TRANS/WP.29/2003/47  
4 April 2003

**PROPOSAL FOR CORRIGENDUM 1 TO THE DRAFT REGULATION:**

**UNIFORM PROVISIONS CONCERNING THE APPROVAL OF TYRES WITH REGARD TO  
ROLLING SOUND EMISSIONS**

Example 1

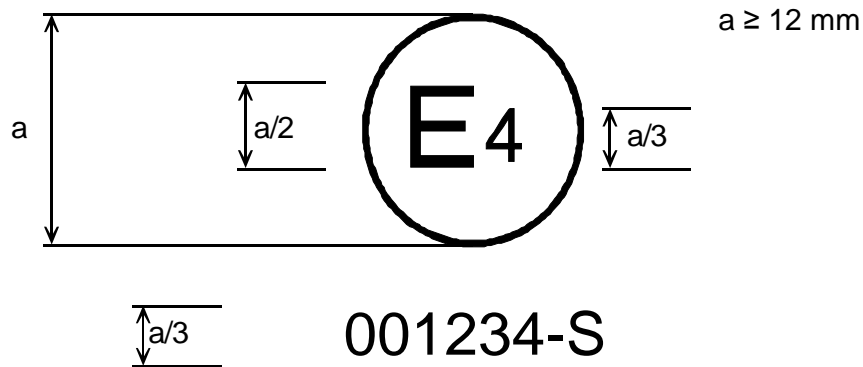
Annex 2, amend to read:

The above approval mark, affixed to a pneumatic tyre shows that the tyre concerned has been approved in the Netherlands (E4) pursuant to Regulation No. XXX (marked by "-S" only), under approval number 001234. The first two digits of the approval number (00) indicate that the approval was granted according to the requirements of this Regulation in its original form.
